**Former Stag Brewery.  
London.**  
**Reselton Properties.**

**SUSTAINABILITY**  
ENERGY STRATEGY ADDENDUM

REVISION 01 - 05 JUNE 2019

Rev.	Date	Description of change / purpose of issue	Prepared	Reviewed	Authorised
00	25/04/2019	For Issue	R. Harper	T. Wigg	G. Jones
01	05/06/2019	Updated following GLA comments dated 23.05.2019	R. Harper	G. Jones	G. Jones

Figure 5: Dwellings assessed (highlighted blue).

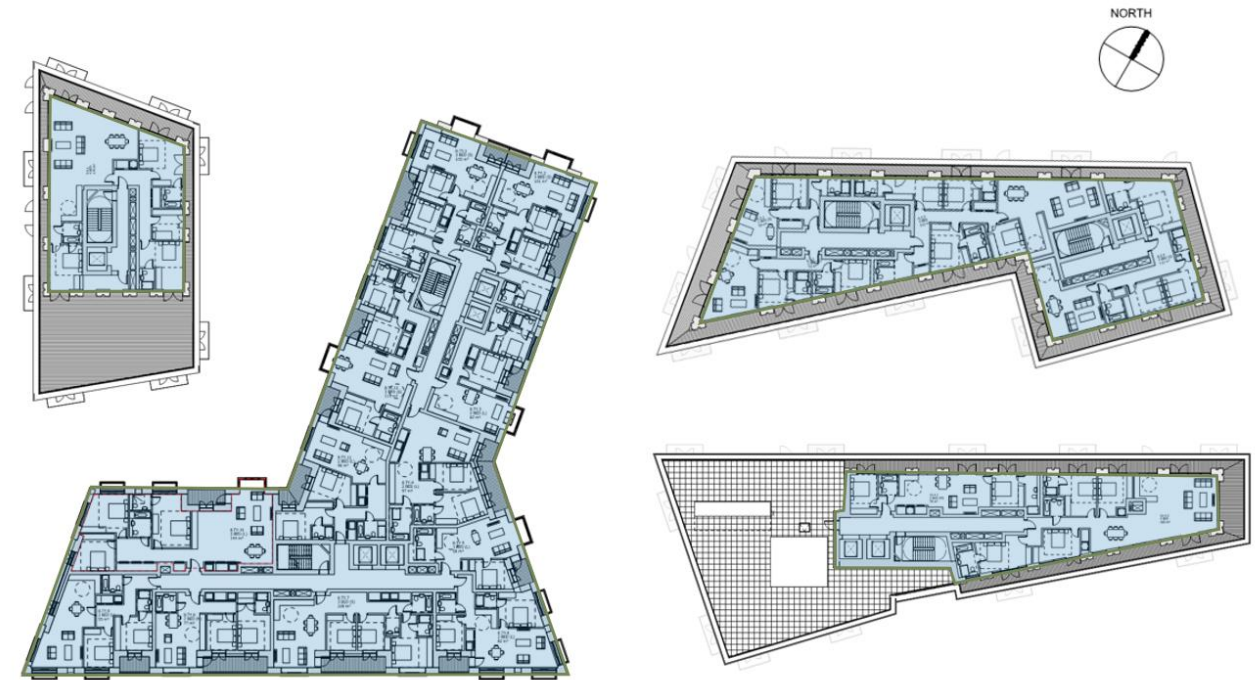
- *Items 5&6: they still need to provide a revised overheating analysis demonstrating that they have investigated additional passive options to further limit the overheating risk for the DSY1 weather file, provide modelling evidence of the mitigation measures considered and submit the revised overheating results. The analysis needs to be carried out for both DSY2 and DSY3 weather files.*

- Response:
    - We acknowledge this further request and confirm that this will be undertaken and results submitted to the GLA (modelling to demonstrate the TM59 criteria are met under DSY1 weather file and modelling and provide the results for DSY2 and DSY3). However, further to our previous response, clarity has not been given to the specific measures the GLA would like to be tested.

Figure C4: Indicative heat network route and connections.

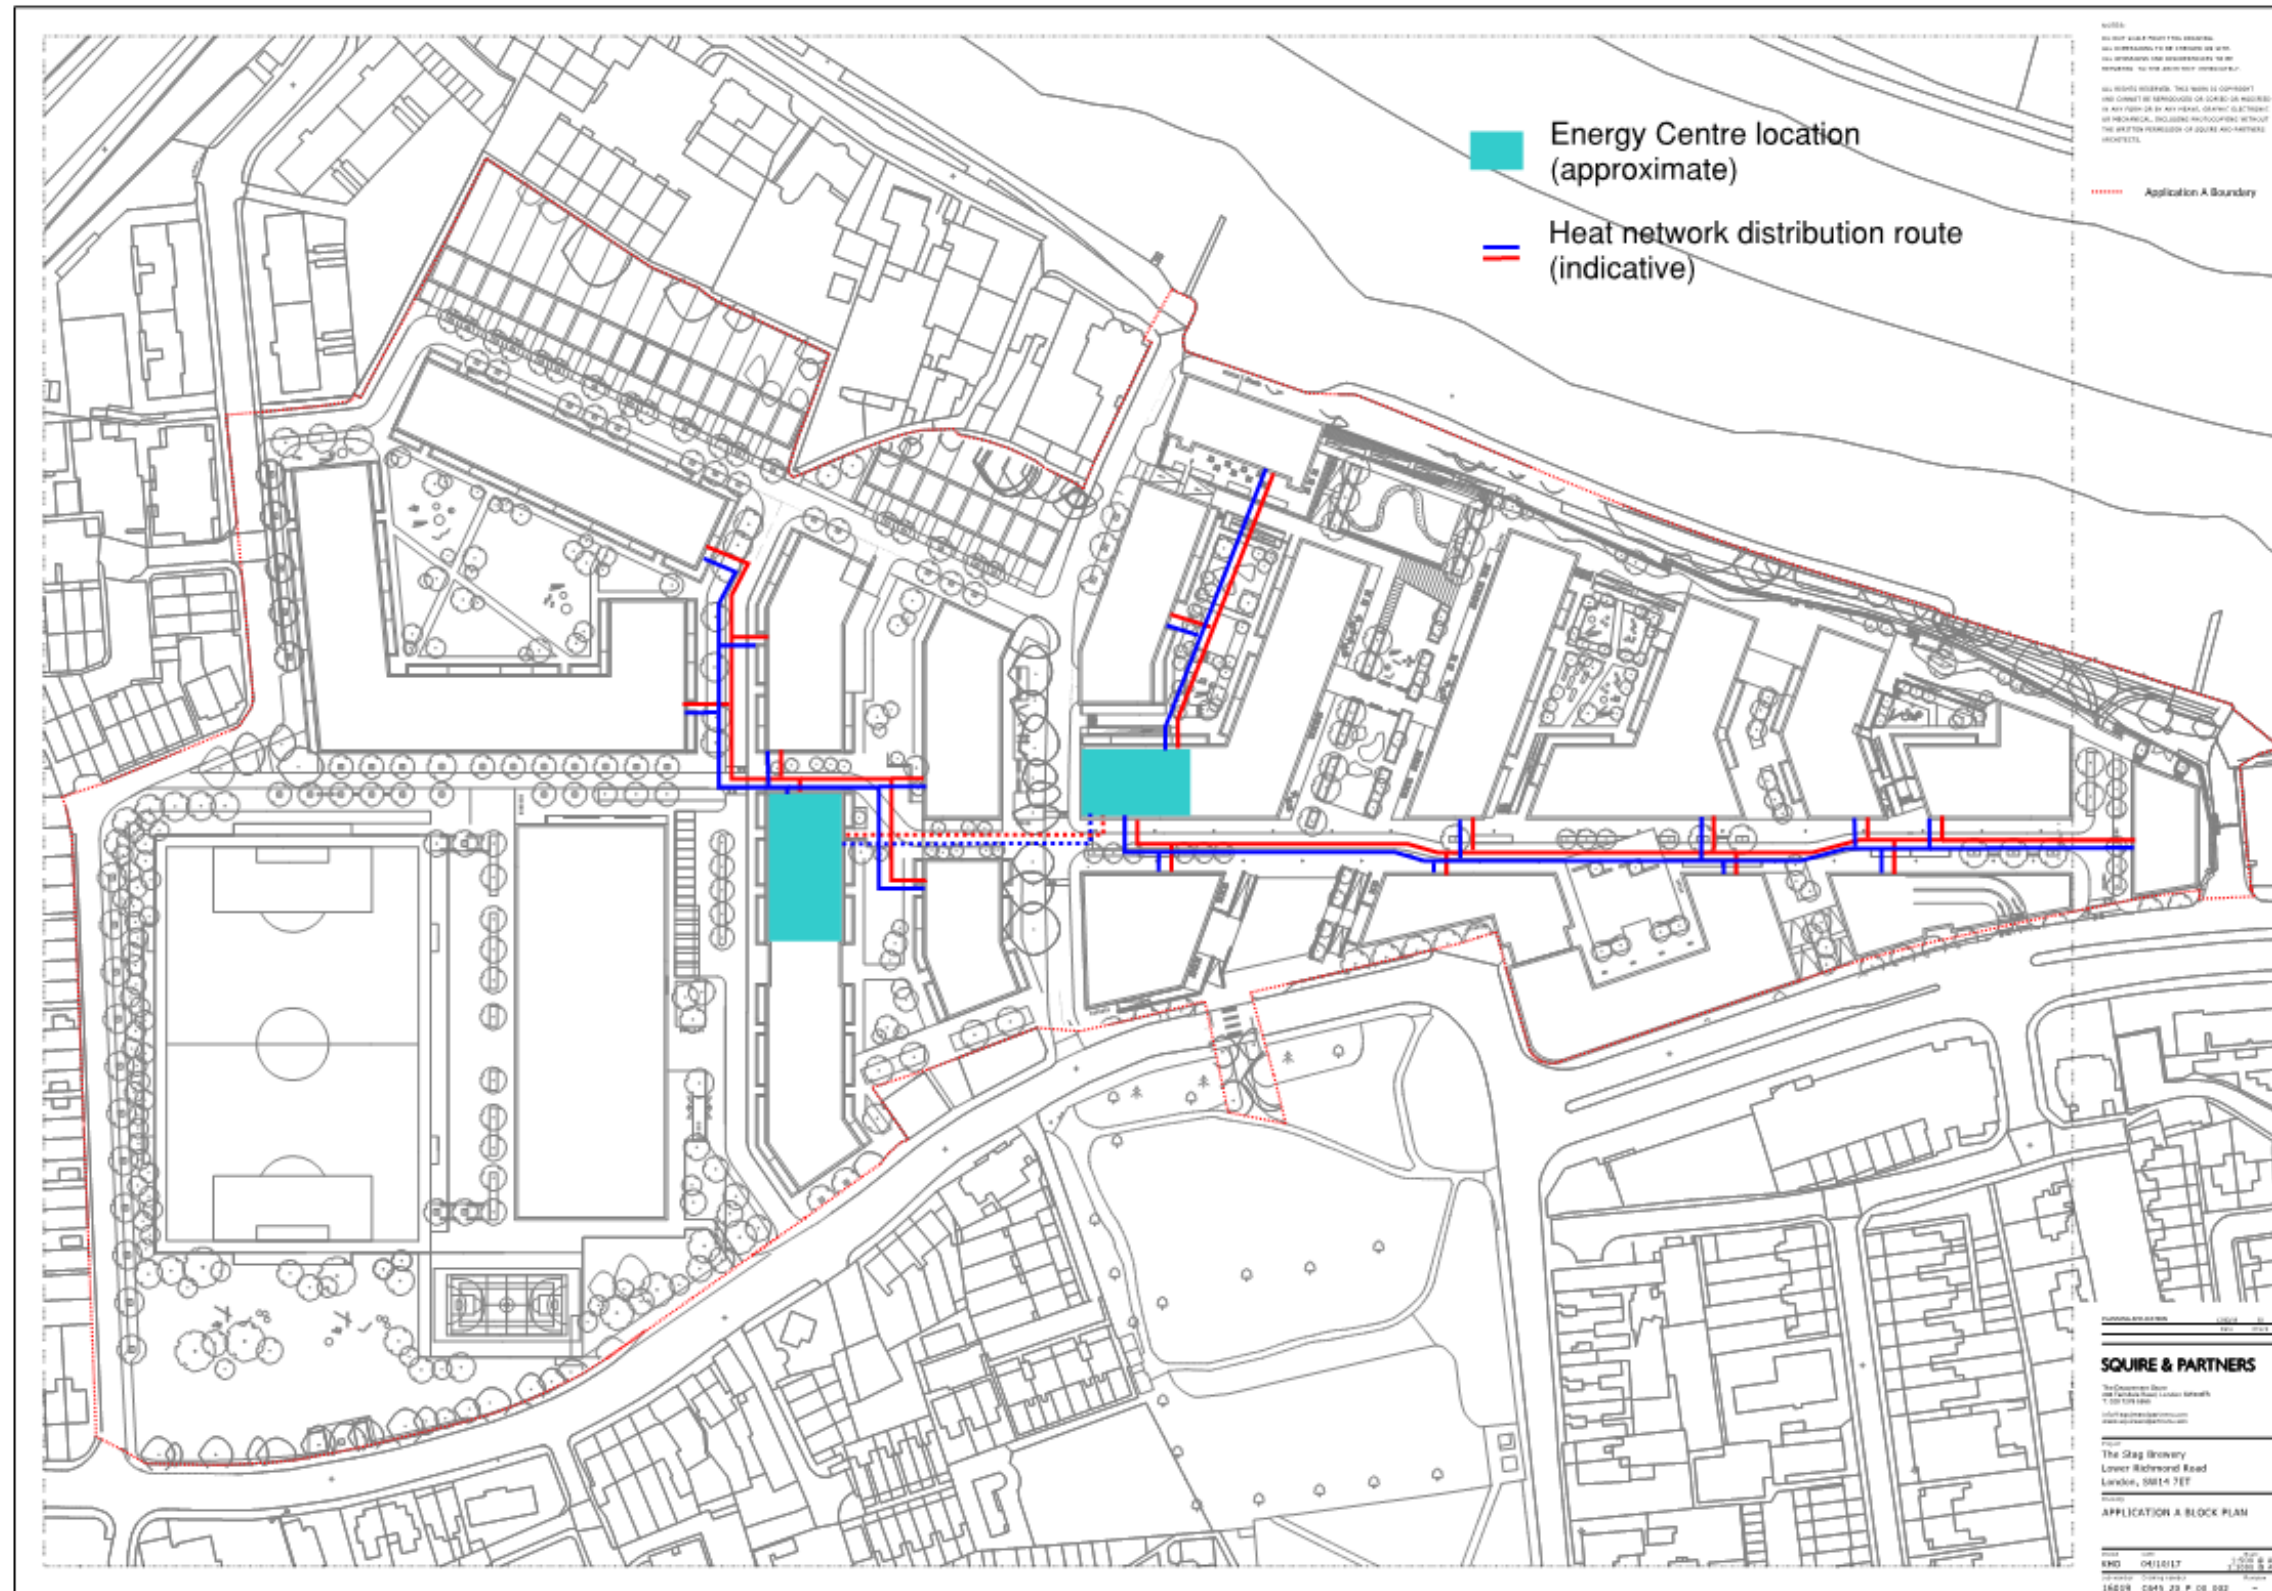
F	<p>The applicant should also demonstrate the likely connection point for the outline and detailed elements of the application in order to create a single heat network on the site which will eventually supply all phases. A condition at each stage of the reserved matters for the outline application will be required to ensure that the applicant will use best endeavours to create the site wide heat network.</p>	<p>The applicant has not addressed this <b>item and it remains outstanding.</b></p>	<p>Appendix E of the submitted Energy Strategy provides an indicative layout of the proposed energy centres on the eastern and western sides of the overall site.</p> <p>There is a commitment to connect the 2 energy centres together via a network of inter connecting pipework to create a single site wide heat network.</p> <p>As noted in the comment it is accepted that this approach is dealt with by a suitably worded planning condition.</p>	<p>Detailed layouts for the energy centres are provided in Appendix C (as previously submitted) indicating how the two are connected, and how they interface with the distribution network, as provided in Appendix A (as previously submitted).</p> <p>The drawings demonstrate how the components will interface to create a single network on-site.</p>	<p>The applicant has provided drawings showing the connection point for the outline and detailed elements of the application in order to create a site-wide heat network.</p> <p>A condition will be required to secure the site-wide network. The applicant has not considered this. However, here is GLA's proposed wording:</p> <p>"The Reserved Matters submission for the Outline proposals (Development Area 2) of Application A (ref. 18/0547/FULL) will demonstrate that connection will be made between the heat networks for Development Area 1 and Development Area 2, thereby creating a single site-wide heat network covering the full site covered by Application A."</p> <p><b>This item is outstanding.</b></p>	<p>The proposed condition wording is considered to be in line with what has been submitted to-date.</p> <p>The wording will require review by the Applicant to agree, however from a technical perspective this in line with the expectation to provide two energy centres either side of Ship Lane to create a single heat network for Application A.</p>
